## REMARKS

Claims 1-29 are now pending in this application. Claims 20-23 have been amended and new claims 28 and 29 added. Applicants note, with appreciation, the allowance of claims 1-19 and 24-27.

*FIG. 3*

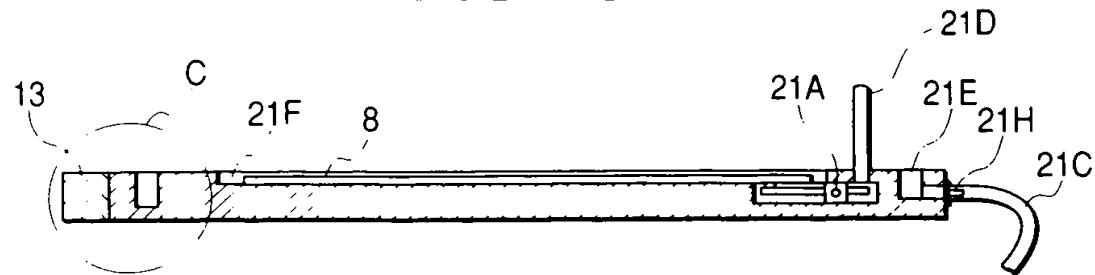
Changes have been made to incorporate the objections made by the Examiner to the drawings. Applicants note that reference numeral 21C in Fig. 3 is mentioned at page 17, line 16. Typographical errors in the specification have also been corrected.
